1 Introduction

This document has been prepared as an Addendum to the Final EIA for the Vlorë Combined Cycle Generation Facility as prepared by MWH and issued October 6, 2003. The information in this Addendum is intended to address additional comments by the Albanian Ministry of Industry and Energy, the World Bank, EBRD, and EIB following release of the Final EIA. *This Addendum should be read in its entirety and in conjunction with both the Executive Summary and Main Body of the Final EIA.* Please note that the officially released version is the hard copy version with the aforementioned date, as it includes information that is not available in electronic format.

Figure A.1

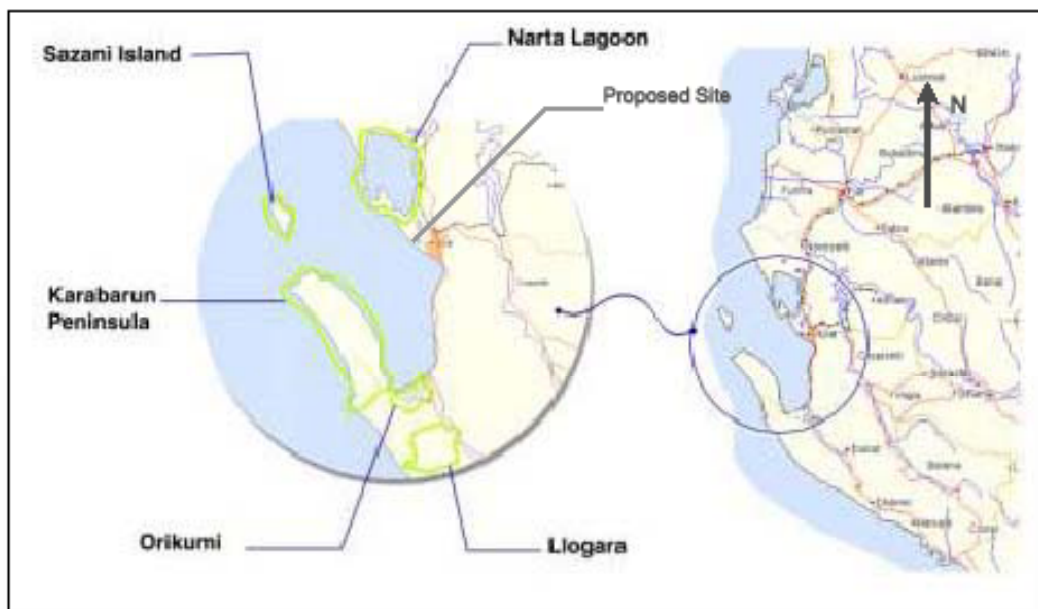
Figure A1 shows the location of the proposed site relative to the surrounding proposed protected areas. The Albanian law on protected areas is still in development. However, the proposed law includes provisions that preclude certain types of development within the protected area boundary. These types of development are discussed further in Section 3 of the Final EIA. And as stated in the Final EIA, the closest proposed protected area is the Narta Lagoon. The proposed boundary for the Narta Lagoon does not include the proposed site or the existing offshore oil terminal.

Figure A.2

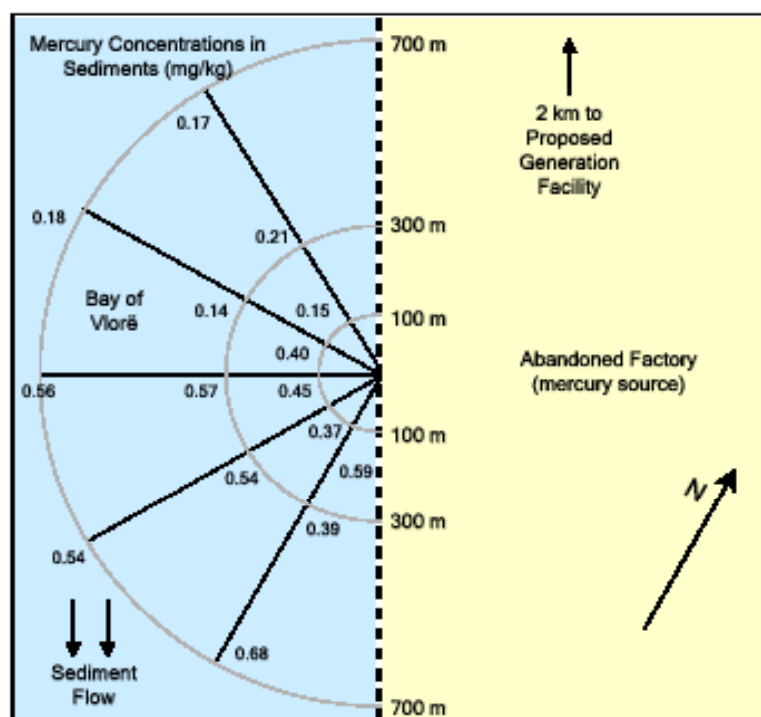
With respect to mercury-contaminated sediments in the Bay of Vlorë, there is no site-specific data available concerning the seabed in the immediate vicinity of the proposed generation facility. However, mercury contamination is prevalent at an abandoned PVC and soda factory located approximately two km south of the site. The source has been closed since 1992 and is no longer an active source of contamination. Available information on the extent of the mercury and other heavy metal contamination of sediments in the Bay of Vlorë from that closed factory extend 700 m into the bay and are approximately 1,800 to 2,000 m South of the proposed intake and 1,100 to 2,000 m South of the proposed discharge structure. This information is included in Table 5.5 of the Final EIA. The information on mercury concentrations from Table 5.5 of the Final EIA is summarized in the Figure A2 below.

The concentrations are lower to the north of the abandoned factory as you move toward the proposed Vlorë B site. This is due to the sediment movement in the bay generally flowing to the south, away from the site. Based on this information, it is not anticipated that any dredging material will contain high concentrations of mercury or other heavy metals from the abandoned factory. As a precaution, the construction mitigation plan contains sediment sampling and analysis requirements to ensure that contaminated material is handled properly.
